APPLICATION FOR VARIANCE FROM EPB RULES

We have performed an initial technical review of your application for a noise variance, revision dated November 5, 2018. Prior to completing the technical review, and being comfortable recommending that the Environmental Protection Board (EPB) issue a noise variance for the project, we will need some additional information (I do like how you specified what equipment will be operating at night and for how long – that is very helpful). Specifically,

To: Reichle, Erich
Subject: RE: Noise Variance Application - 200 Riverside Ave Project

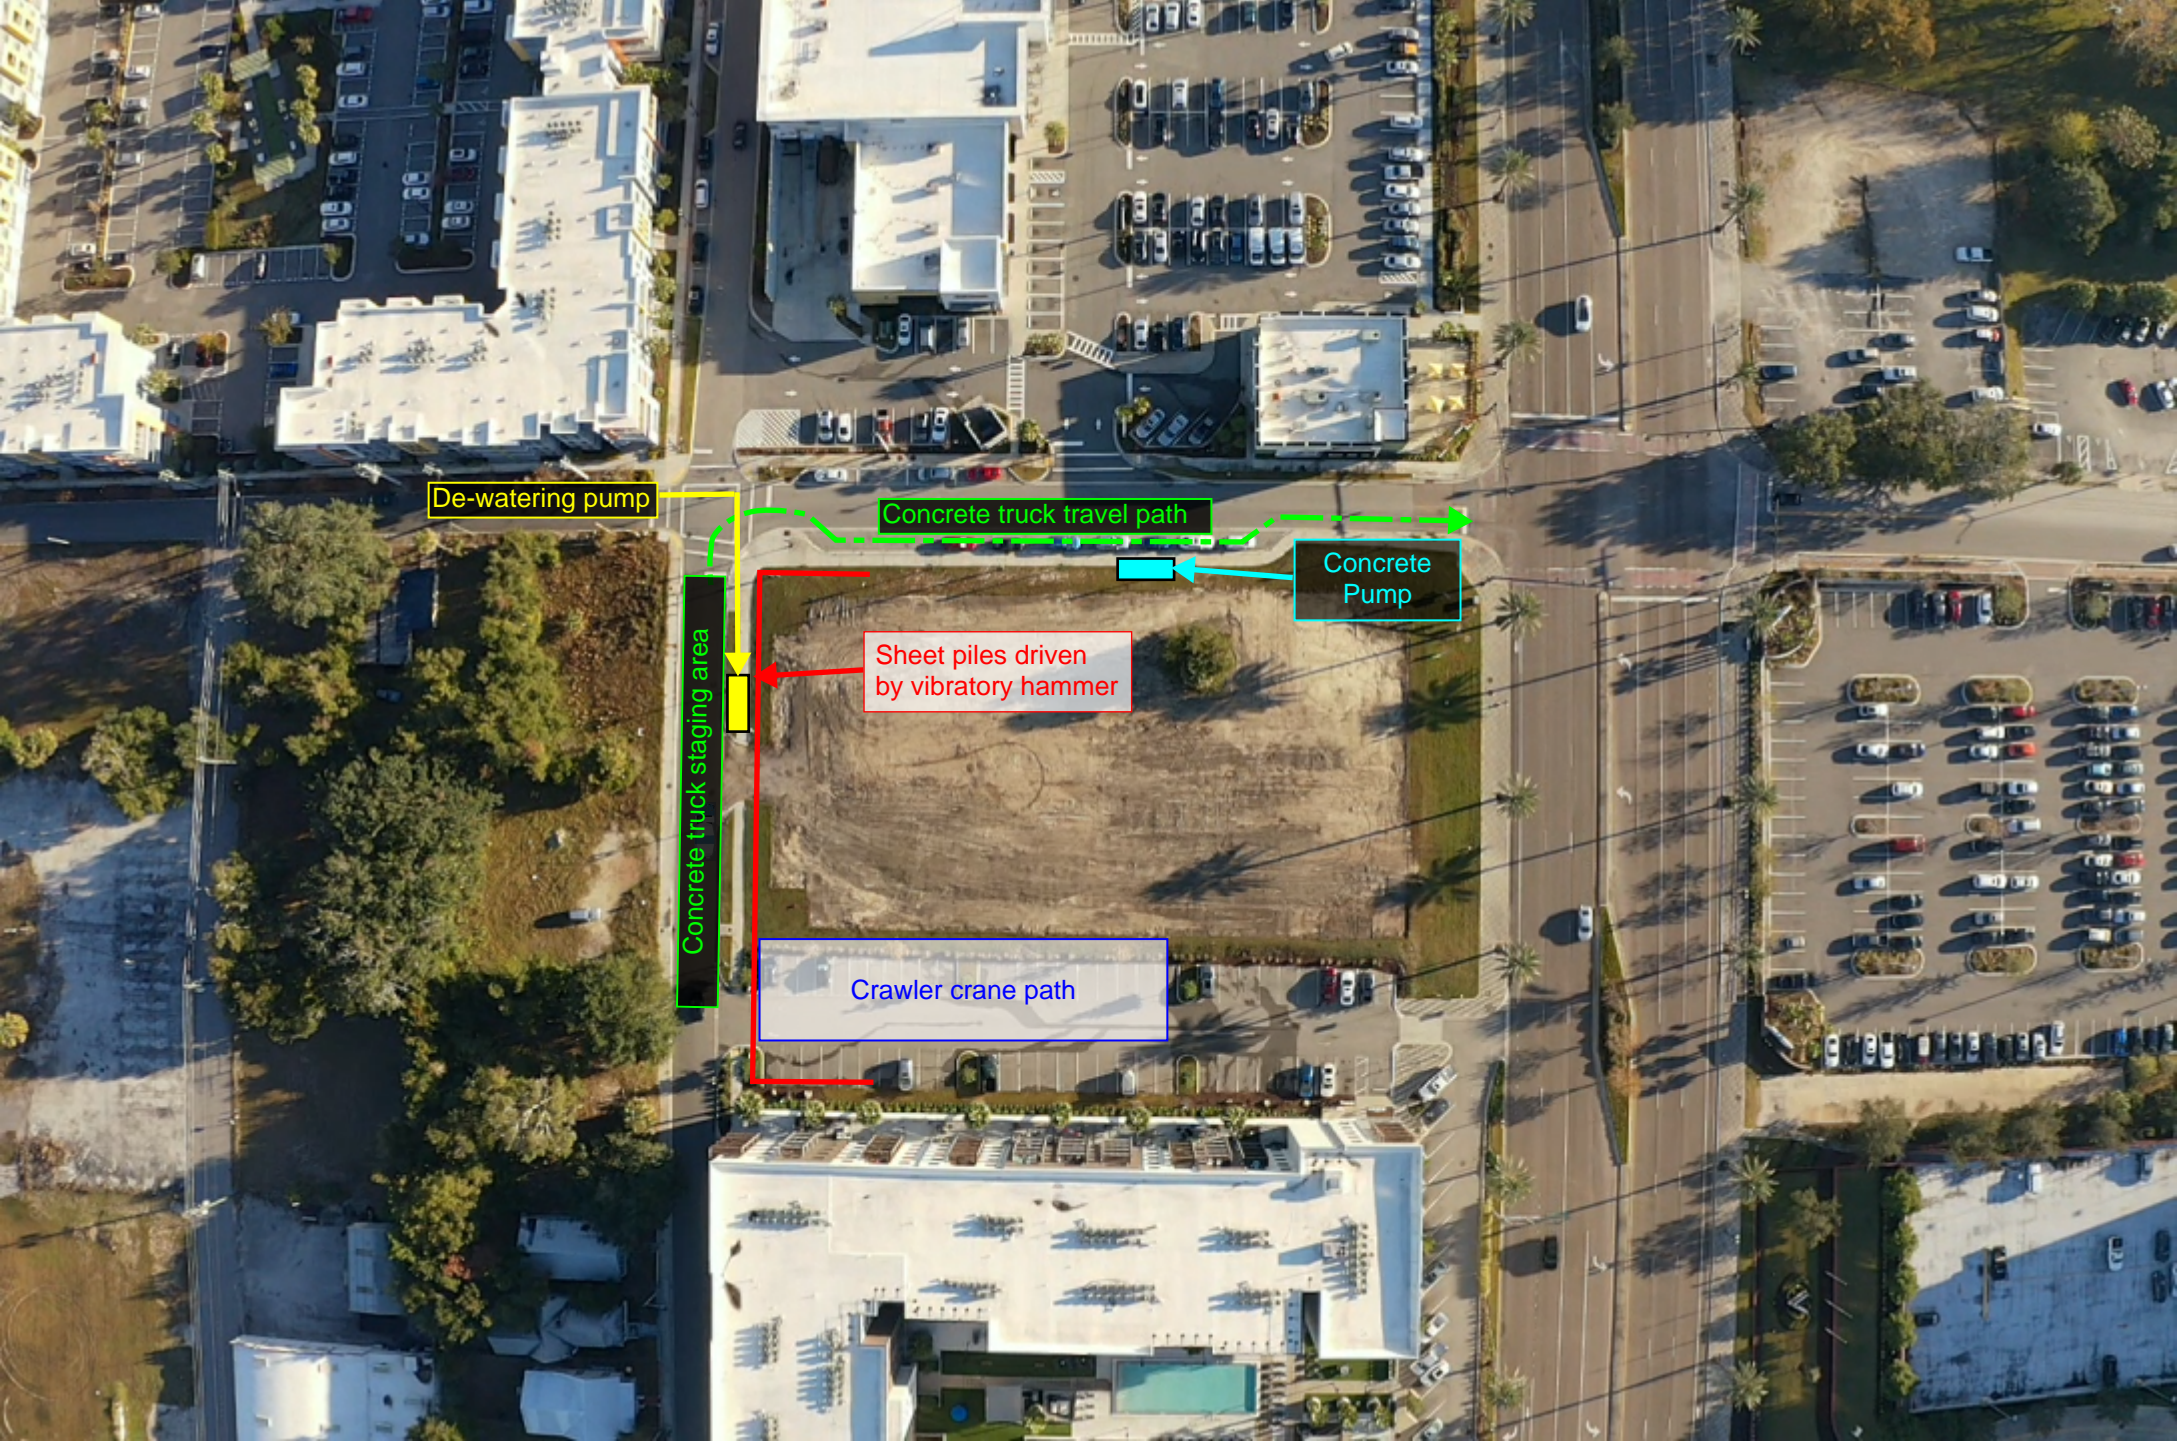
2. We normally require a site diagram showing the anticipated location of the equipment. I understand that your construction site is small, but if some of your equipment will be primarily operated in a certain area of the site, it would be helpful to know that so we can estimate the impact to the receptors. If not, please explain. Also, please indicate where you anticipate the concrete pump truck to be located when doing night pours and where the concrete trucks will stage, how they enter and leave the site, etc. **Please see the attached map indicating our planned operating locations for dewatering pumps, vibratory sheetpile hammer, and crawler crane. Additionally, we have identified the location for our concrete pump and staging/travel paths for concrete trucks.**

3. Your map or diagram needs to identify all Class A and B properties that may be impacted. **See attached map for all Class A and B properties in the surrounding area.**

As much as possible, we have attempted to locate equipment generating the loudest noise emission away from surrounding receptors:

By using an electric dewatering pump, this should eliminate the need for a variance on this piece of equipment all together. However, in the unlikely event our backup diesel pump must be used, we will provide sound blankets to help mitigate the noise. The pumps must be placed within 100 ft of the storm sewer system which limits the location to along the closed section of Magnolia Street as shown on our equipment location map.

The vibratory hammer for installation of the temporary sheetpiling will also traverse along the closed section of Magnolia Street as shown on our equipment map. This is a very short duration activity of 1 week for installation and 1 week for removal. Subsurface materials are loose to medium dense sands so pre-augering should not be necessary. While installing

The crawler crane used for erection of the precast parking garage will operate in the areas shown on the equipment plan. This will be a moderate 12-week duration activity and similarly to the vibratory hammer, sound wave refraction will expose residents in upper floor units. Once the parking garage is erected, however, it will then act as a sound barrier between the new apartment tower construction and 220 Riverside Apartments.

We anticipate using the electric tower crane primarily for placing elevated concrete. However, there will be instances where a concrete pump is necessary. In this case, the plan is to have a pump located along Jackson Street as shown on the equipment map. Concrete mixer trucks will stage along Magnolia and either load the crane bucket there or move through the closed area of Jackson Street to the concrete pump. Air off will occur along the southeastern end of Jackson Street near Riverside Avenue which is the farthest point away from residential receptors.

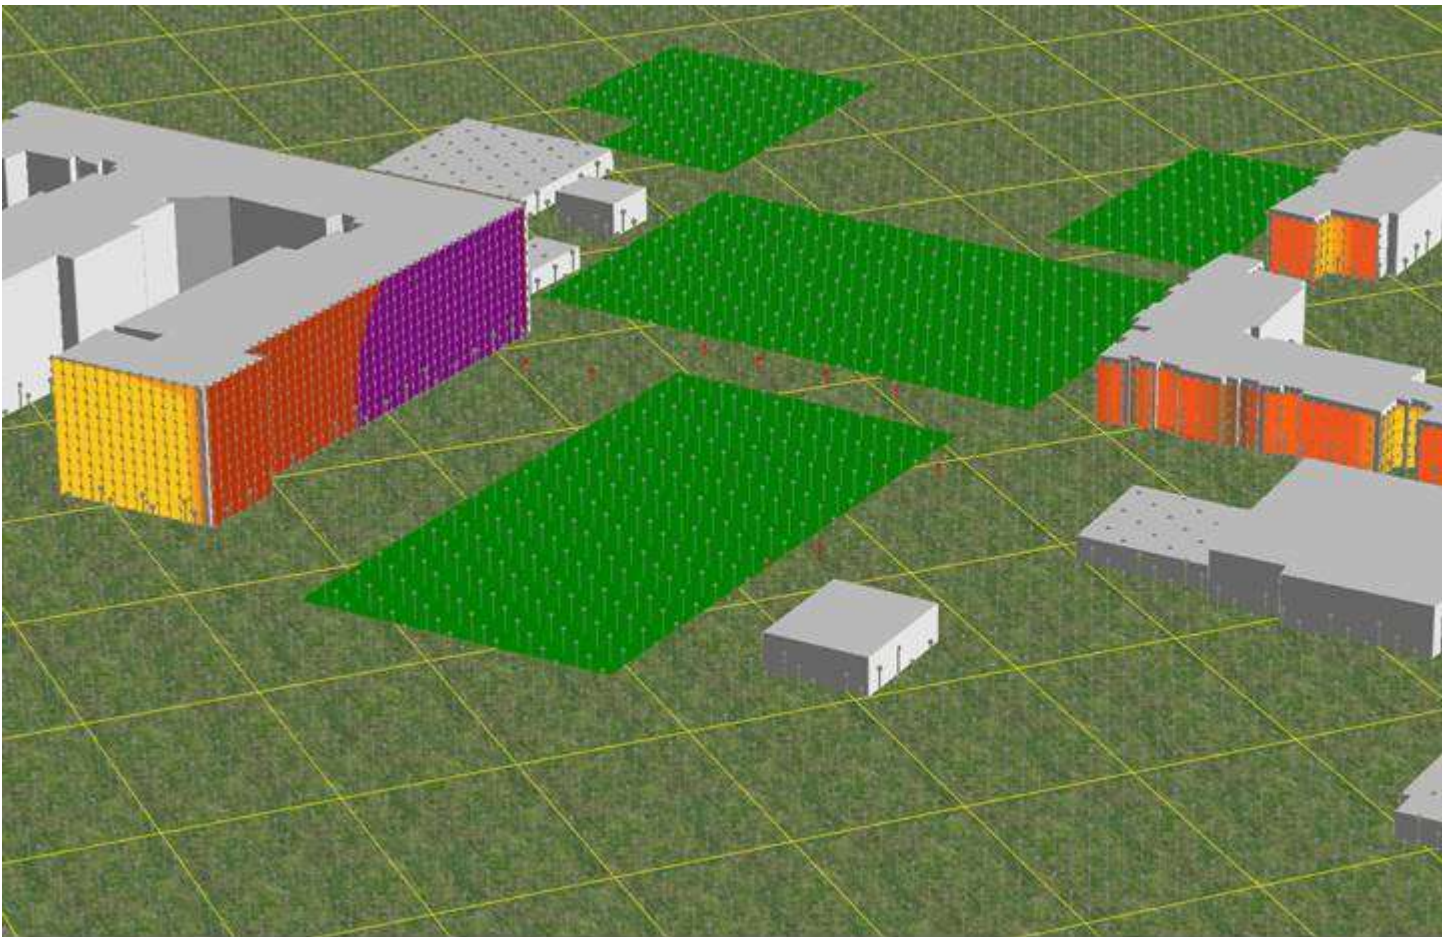
I understand that the duration of the sheet piling is only one week, followed by a week of removal. Even though it is of short duration and a daytime only operation, my modeling shows some significant noise impact on the 220 building next door (see the diagram below – the purple region is predicted to be 100 – 110 dBA) so I would like to be able to ensure the board that you are taking all reasonable mitigation measures or that there are no reasonable mitigation measures available. I understand from your last email that use of a hydraulic press would be very expensive. Would you mind asking your sheet piling sub about the possible use of something like a variable moment hammer, which I understand is much quieter and makes much less vibration? I understand that a company here (there may be more than one company with this type of equipment) in Jacksonville has this type of hammer if it is practical for your project.

Regarding the sheet piling, we are using a variable moment hammer which Hayward Baker says will significantly reduce the decibel levels, especially considering that we have medium to loose sands onsite. I've attached some information they provided here for your reference.
